BANGLADESH APON CHULA IMPROVED COOKSTOVE PROGRAM II

Project Title	Bangladesh Apon Chula Improved Cookstove Program II
Version	3.0
Report ID	VCS.VAL.23.36

Report Title	Bangladesh Apon Chula Improved Cookstove Program II
Client	Guangzhou Iceberg Environmental Consulting Services Co., Ltd.
Date of Issue	14-July-2025
Prepared By	Earthood Services Limited, formerly known as "Earthood Services Private Limited"
Contact	Emaar Digital Greens, Tower B, Unit No- 1203-1205, 12th floor, Sector-61, Gurgaon- 122011, India Tel: +91 124 4204599 Fax: +91 124 4204599 Website: www.earthood.in Email: operations@earthood.in

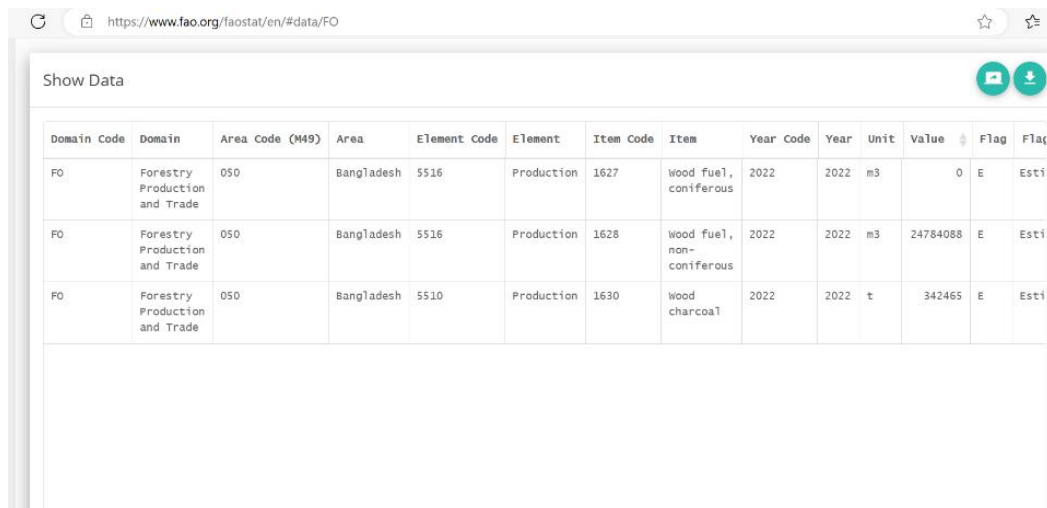
CL ID	04	Section no.	3.3.4	Date: 15/05/2023
Description of CL				
<ol style="list-style-type: none"> Under section 3.2 of PD, how will the PP differentiate between the ICS distributed under PA 3144 and 3168 since both the programme logo will be the same? Please clarify if there is overlapping of project boundary between the two PAs. Under section 3.3 of PD, there is no clarity on the baseline stove and fuel used in baseline stove referring to published literature, official reports or statistics in the host country. 				
Project participant response				Date : 17/05/2023
<ol style="list-style-type: none"> The ICS under PA 3168 are distributed by Grassroot and Kheya, ICS under PA 3144 are distributed by HWO and ACOB. Four distributors are in charge of different area of Bangladesh. Furthermore, every ICS has a unique serial number on it. The serial numbers for programme I belong to 000001 to 200000 and 600001 to 800000 while those for Programme II belong to 200001 to 600000. Please refer to submitted document "20_Photo of improved cookstove". Modified to: As of 2020, only 19% of the population in Bangladesh had access to clean cooking. In 2018, 74% biomass stoves were used in Bangladesh. The source of data is published literature and official report by World Bank in Bangladesh.

NA	
VVB assessment	Date: 09/06/2023
<p>The pre project scenario is confirmed to be the use of traditional inefficient stoves for cooking in Bangladeshi households.</p> <p>CL#04 is closed.</p>
